RE: Planning Application Reference 2017/7080/P – Channing Junior School, London N6 5JR

On behalf of the Highgate Society, I would like to re-iterate our objection to the above application and respond (in red) to the applicants second response as follows:-

Response to The Highgate Society's Comments dated 19th April, 2018

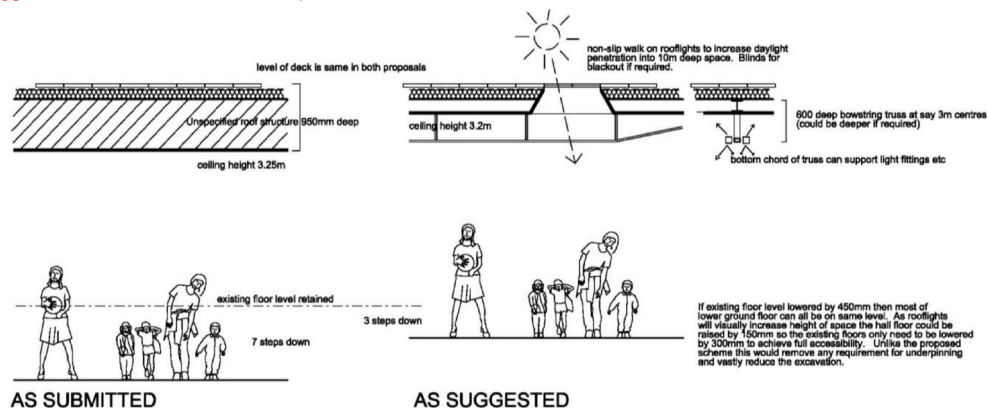
2. The School notes the views of the Society, but recognises this is a matter of opinion and as previously stated, we believe that the extension remains in proportion to the rest of the building. I cannot think of any successful precedent that would support the schools view that such a large projection is in proportion with the rest of the building. Fairseat House or what remains of it should not appear propped on top of such a large plinth. Any reduction that is possible without losing essential space from within the hall should be seriously considered and not ignored. Were the school to seek to implement the suggestions made then it would result in

- A significant reduction in the circulation space reducing this to an unacceptable level for its multi-use levels. The only reduction in circulation space is the removal of a very wide flight of 7 steps which in themselves pose a hazard to young children, particularly when it is crowded. The circulation space outside the new hall in our suggestion is actually widened to create a decent size lobby, all on the same level. Further the typical use of the building in the daytime will typically result in very high volume use at specific times of the day such as assemblies. The design as submitted considered this by allowing for appropriate circulation space.

- Reductions in the planned roof space which is intended as a play area. The suggested reduction in the size of the roof results in a corresponding increase in play area where it currently is, on the ground.

- The kitchen being reduced to an unacceptable size such that it would not be able to cater for pupils and staff. The kitchen size is actually 3sqm larger and all of the existing kitchen equipment is shown on the proposed layout.

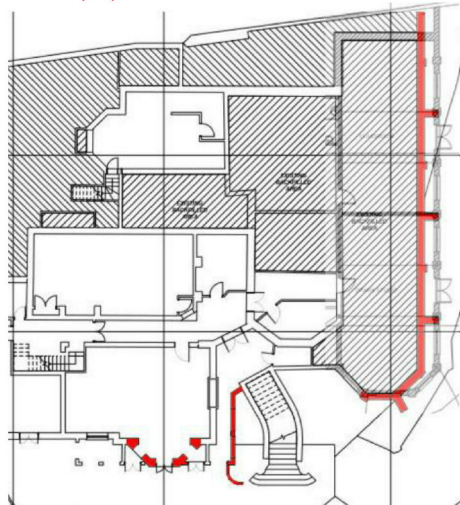
- Minimal disruption to the existing classrooms on upper levels
- A minimal impact on the existing building. **New cloister collides with existing garden stair.**
- A clear span multi use space to accommodate the school's needs for assemblies, meetings, PE and catering
- Due consideration of the existing architectural style. **The plinth is out of proportion and to be that long is unnecessary.**
- Retention of existing architectural features. **The cloister is being demolished as is the retaining wall supporting the terrace to the SE of Fairseat. I do not believe this was made clear in the heritage report and it requires careful consideration. The plan below shows the location of the existing wall and the proposed wall. The elements to be demolished are shown in red.**
